DC2296 Demo Manual Page 11, Figure 10

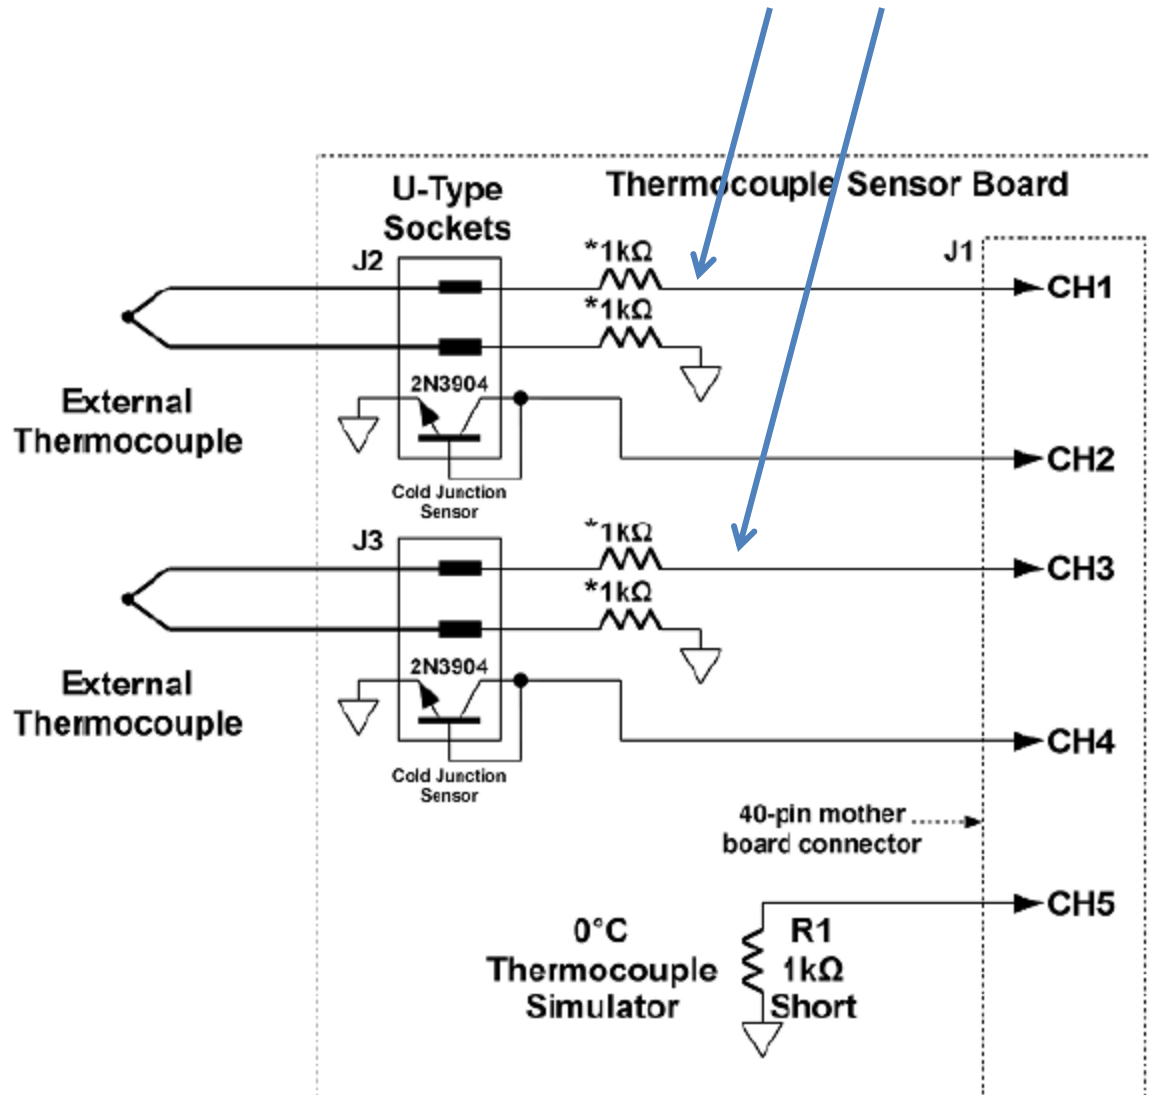
1. Any problem adding a LC noise filter?
2. Any problem adding a pull up resistor for disconnected line detection?
